NOTES: (UNLESS OTHERWISE SPECIFIED)
 MAKE 1 FOR LLO VERTEX
 303/304 STAINLESS ASSEMBLY

ITEM NO.	REQ.	SPARE	TOT. QUANTITY	PART NUMBER	DESCRIPTION	SUPPLIER
PARTS LIST						
UNLESS OTHERWISE SPECIFIED: DIMENSIONS ARE IN INCHES				DATE	NAME	LIGO CALIFORNIA INSTITUTE OF TECHNOLOGY MASSACHUSETTS INSTITUTE OF TECHNOLOGY
TOLERANCES: .XX±: .XXX±: ANGULAR:±				DRAWN	4/21/04	KENM
MATERIAL SEE NOTE				CHECKED		SYSTEM EPI
FINISH NA						SUB-SYSTEM HEPI
						NEXT ASSY TBD
				COMMENTS:		PART NAME LLO VERTEX GAGE AND SENSOR FITTING
SIZE B		DWG. NO. D040229-A		REV A		
SCALE:						SHEET 1 OF 1

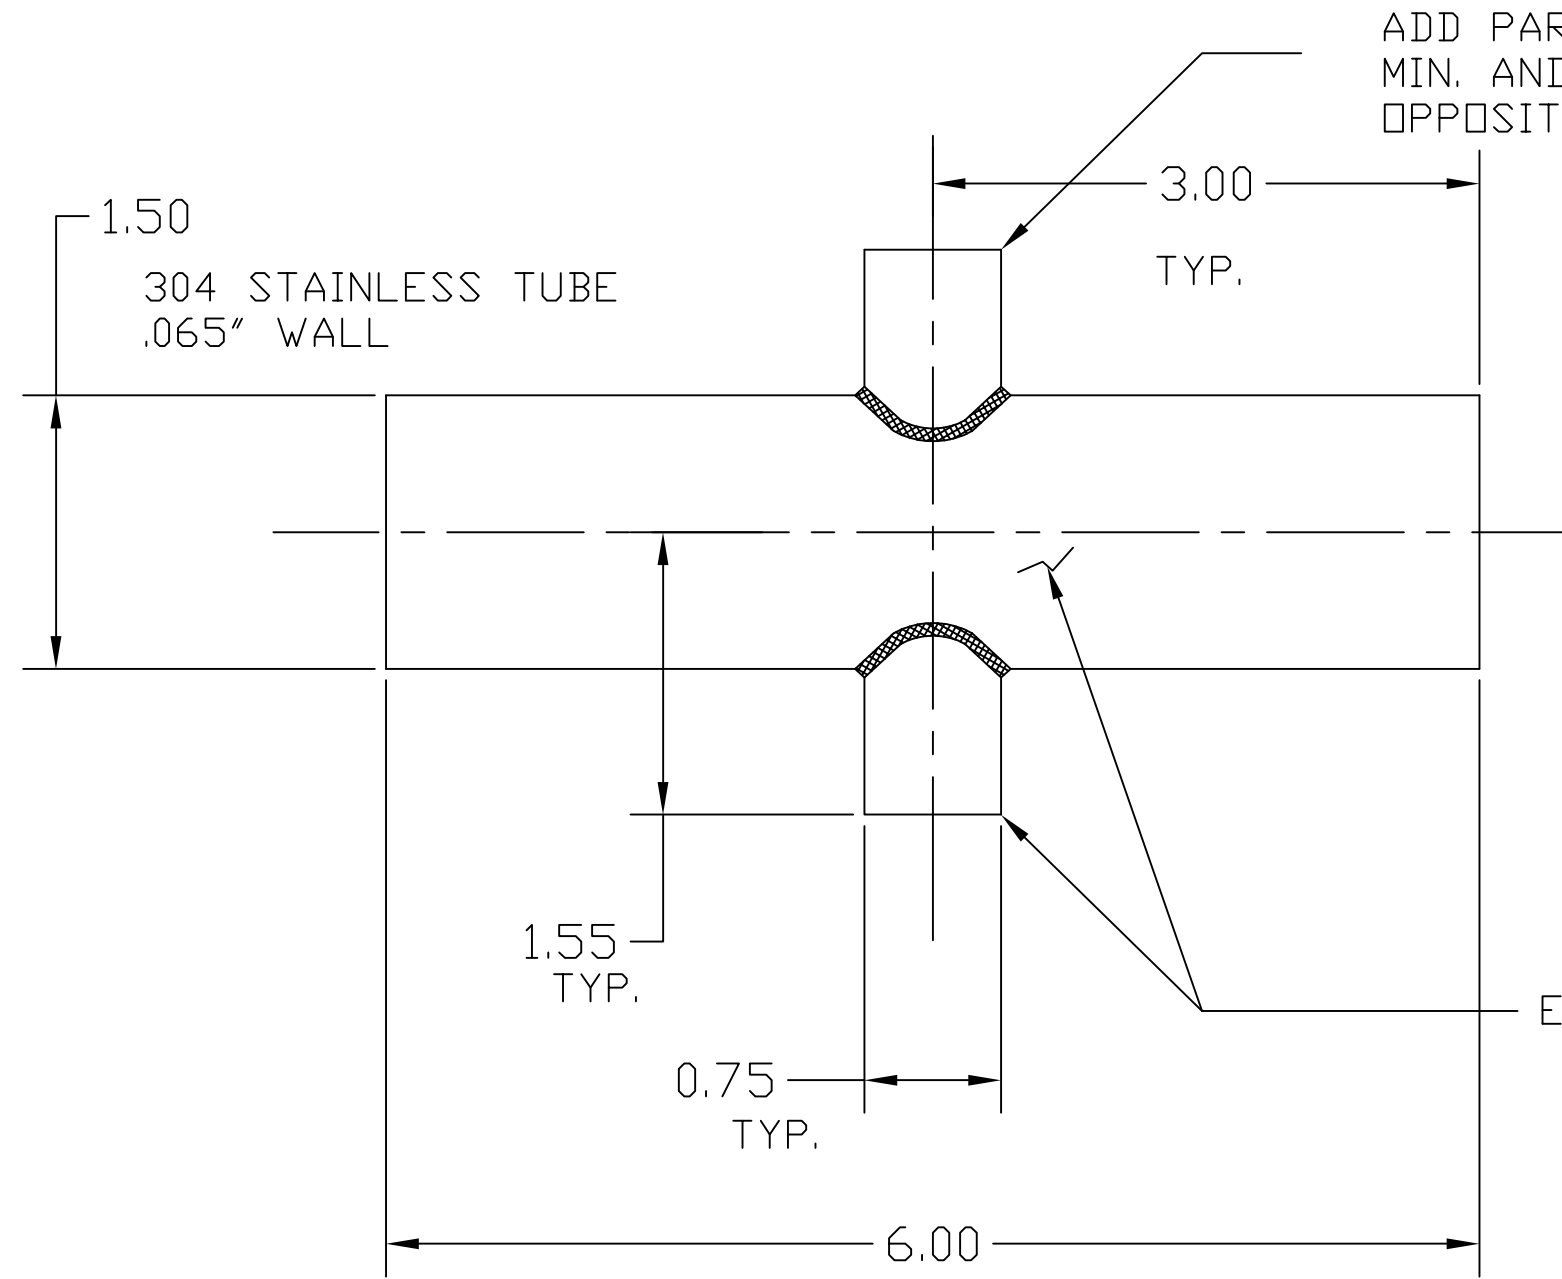
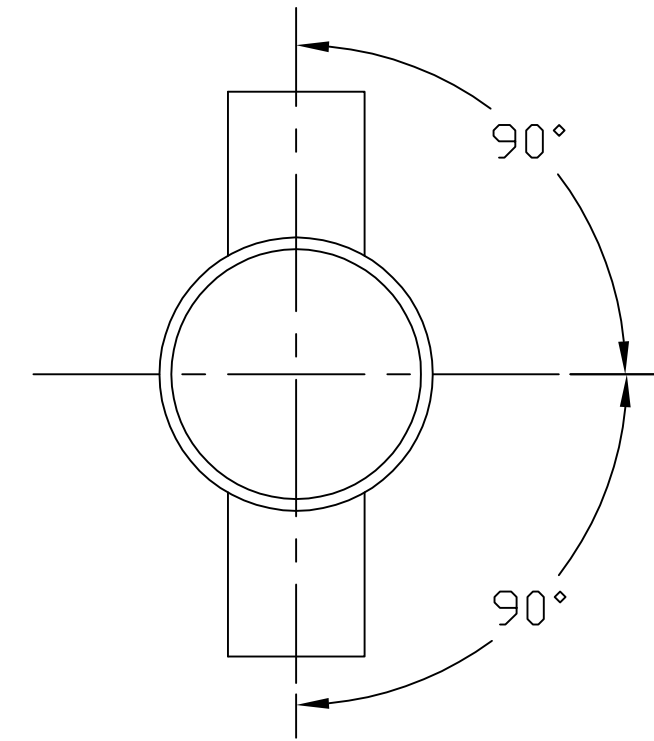
ADD PART W/ 7/16-20 THD .50 DEEP
 MIN. AND #33 PORT FEATURE [SAME AS
 OPPOSITE SIDE]

SEE D040213-A FOR
 LOCATION
